Access Compliance Report

Public Rights-of-Way

Intersection ID: 10637	Main Street: COKER_AV	Cross Street: MATHIS_DR	Location: E
ADA ID: B4AC8E7F32C3	Ramp Type: Directional1	Initial Pass/Fail: Fail	Overall Compliance: No
		Severity Score: 12.5

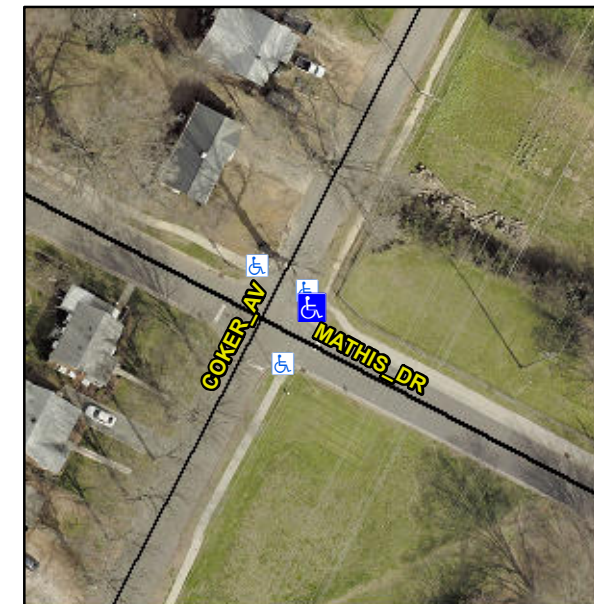
R304.2.2

Compliance	Description	Data	Compliance	Description	Data
N/A	Ramp Length (in)	52.0	N/A	Grade Break?	N/A
Yes	Ramp Width (in)	57.0	N/A	Grade Break Slope (%)	0.0
No	Ramp Slope (%)	8.5	N/A	Grade Break XSlope (%)	0.0
Yes	Ramp XSlope (%)	0.5			
N/A	Flare Type LT	N/A	N/A	Flare Type RT	N/A
N/A	Flare Slope LT (%)	N/A	N/A	Flare Slope RT (%)	0.0
N/A	Flare Traversable LT?	N/A	N/A	Flare Traversable RT?	N/A
N/A	Landing Length (in)	0.0	N/A	DWS Provided?	N/A
N/A	Landing Width (in)	0.0	N/A	DWS Contrast?	N/A
N/A	Landing Slope (%)	0.0	N/A	DWS Length (in)	N/A
N/A	Landing X Slope (%)	0.0	N/A	DWS Full Width?	N/A
N/A	Landing Curb? (Y/N)	N/A	N/A	DWS Offset LT (in)	N/A
N/A	Shared Landing?	N/A	N/A	DWS Offset RT (in)	N/A
N/A	Gutter Ponding?	Yes	N/A	Gutter Slope (%)	N/A
N/A	Gutter Lip Ht (in)	0.0	N/A	Gutter X Slope (%)	N/A
N/A	Painted X Walk1?	No		Road Slope (%)	0.1
	X Walk 1 Direction	To SW		Road X Slope (%)	0.6
	X Walk 1 Width (in)	N/A		Clear Space?	N/A

Remove & Replace Entire Ramp.
